## **Water Services Resource Consent Conditions – Assessment of Application**

Date: 23 May 2022  
SR505203 – 292 Main Road

**Figure 5 Existing Stormwater Infrastructure in the vicinity of the site (Ref.: Wellington Water online GIS)**

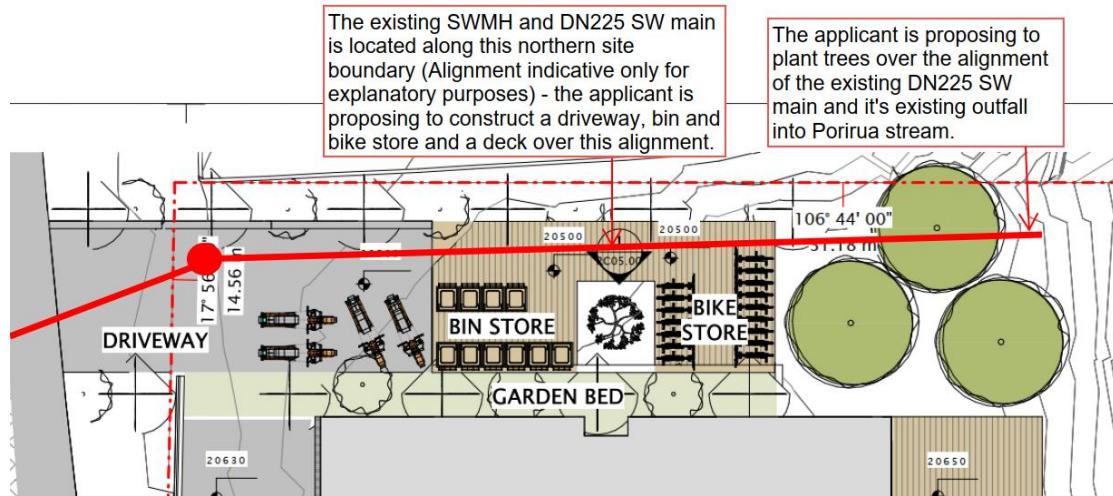
26. The site includes an existing council owned DN225 concrete gravity main which conveys stormwater from the upstream network and discharges it into the Porirua Stream. The main runs inside and approximately paralleled with the northern site boundary.
27. The stormwater main outfall is identified on the applicants topographic survey. The public main upstream of the outfall has not been accurately located.

**Figure 74 Applicant's Proposal to build over the existing SW main along the sites northern boundary (ref.: Archaus Drawing Set – 21026 292 Main Road Tawa – Rev 1, 15/11/2021)**

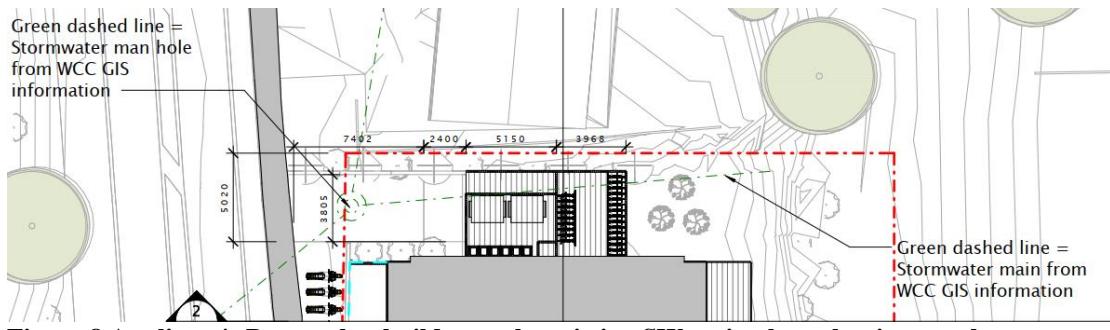
- Raise ground levels over the proposed stormwater main. Site sections appear to show retaining at the rear of the bike store.
- Plant trees over the public stormwater main,
- Build bin and bike storage over the public stormwater main.

Proposal	Implications	Acceptability	Relevant Clause(s)
Bin storage and bike storage over the alignment of the existing Council SW main	<p>In its current form it is not clear how access to the Council main and outlet will be achieved in the long term.</p> <p>The applicant will need to demonstrate that appropriate long term access can be achieved to both the public main and outfall. This may require amendment of the bin store, bike store and site levels.</p>	Unacceptable.	<p>Wellington Water Regional Specifications for Water Services (2021)</p> <p>Cl. 3.8</p> <p>Cl. 4.2.2(c)</p> <p>Cl. 4.4.12</p>

- 26) The development layout and levels must achieve a minimum 10 m set back to the Porirua Stream.
- 27) The existing public gravity stormwater main and outfall must be accurately located on site and the site layout must achieve at least 1.5m clearance from any building works including bin store, bike shed and any retaining walls so that access to the pipeline and outfall is not impeded or alternatively the stormwater main can be re-laid to achieve a minimum 1.5 m clearance.

**Figure 8 Applicant's Proposal to build over the existing SW main along the sites northern boundary (ref.: Archaus Drawing Set – 21026 292 Main Road Tawa – Rev 2, 28/01/2022)**

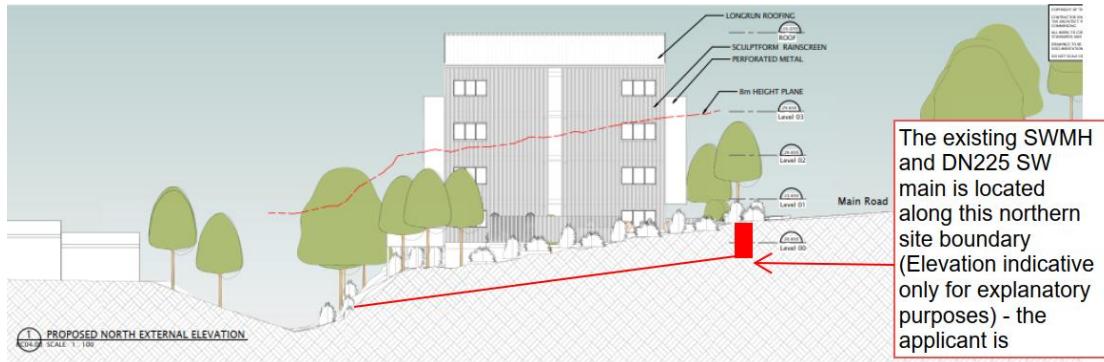
Revised drawings submitted by the Applicant in January 2022 confirm this intention.

**Figure 10 Modelled onsite flooding (1 in 100 year Annual Return Interval + 20% Climate Change Intensity) onsite (Ref.: ArcGIS, WCC Combined 100yearCC Flood Zones)**

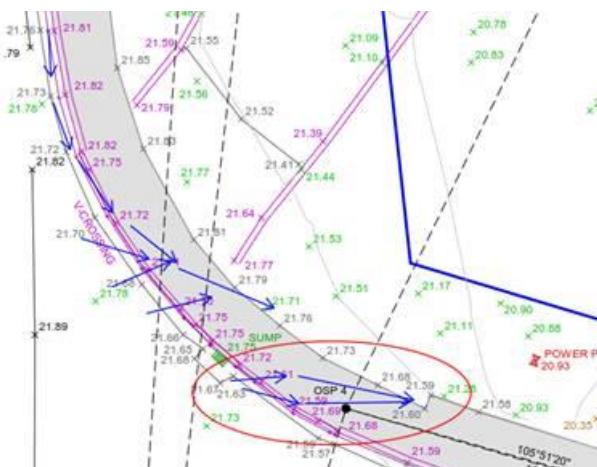
46. Both the WWL and GWRC flood modelling show an isolated pocket of flooding near the northern site boundary. The ground level in the location of this flooding is approximately 18.79 to 19.24 m aMSL. The WWL modelling confirms a maximum depth of flooding on site of 200 mm given a top water

47. The ENGEO report does not consider / assess overland flood flow paths through the site from the wider catchment. In addition to flooding from the Porirua Stream the WWL flood modelling identifies an overland flood flow path entering the site from the roading network vicinity of the Main Road / McLellan Street intersection. The WWL modelling team have advised a minimum recommended building level to the undersize of the floor slab of 21 m aMSL, or 0.4 m above the existing ground level.

- 22) Unless otherwise agreed with the Wellington Water Land Development Team under **condition (23)** or otherwise in writing, any residential building constructed on the site must have a minimum floor level of 21 m RL (Wellington 1953 Datum)

- 23) A reduced floor level may be accepted by the Wellington Water Land Development Team if the consent holder provides a site specific engineering assessment demonstrating that overland flood flows entering the site from Main Road / McLellan Street are managed through the site so as not to cause flooding of the proposed building with freeboard as per the Wellington Water Regional Standard for Water Services.

**Figure 51 Overlay of the site layout and topographic survey.**

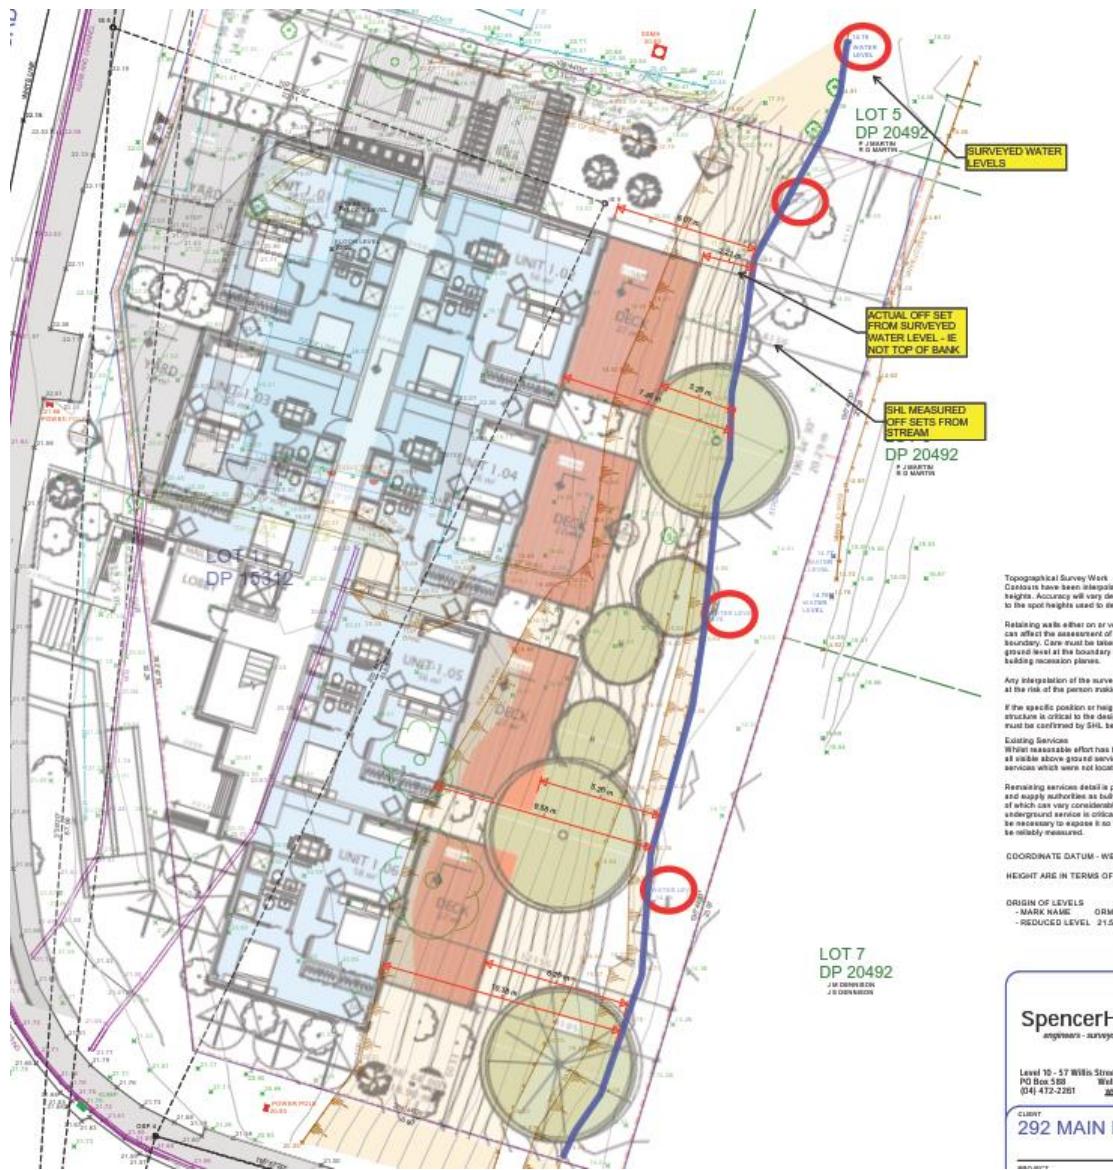
58. Overlay of the development and site topographic survey demonstrates that the:

- a. building is located between 6.0 m and 10.4 m of the stream,
  - b. Decks are located between 2.2 m and 6.3 m from the stream,

63. The proposal does not comply with the requirements of the district plan and Regional Standard for Water Services.

**Figure 126 Proposed planting of trees along the Porirua Stream Bank (ref.: Archaus Drawing Set – 21026 292 Main Road Tawa – Rev 1, 15/11/2021)**

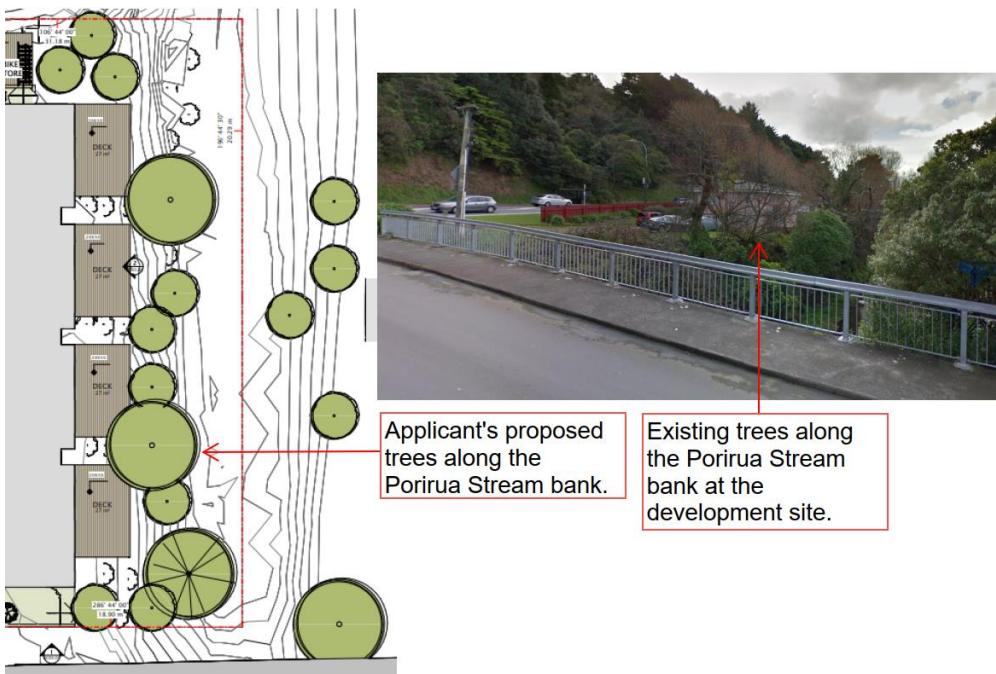
Plant trees over the public stormwater main	<p>Large tree roots have the potential to ingress into the pipe through the joints. Over the long term this has the potential to cause structural failure to the pipe.</p> <p>Tree's will not be permitted within the stormwater main easement.</p>	Unacceptable.

59. In addition to decks the applicant is also proposing a number of tree's along the stream bank between the deck and stream edge.

- 29) The site landscaping plan must be agreed with the Wellington Water Land Development Team to ensure trees and shrubs are maintained clear of the public stormwater main and Porirua Stream.
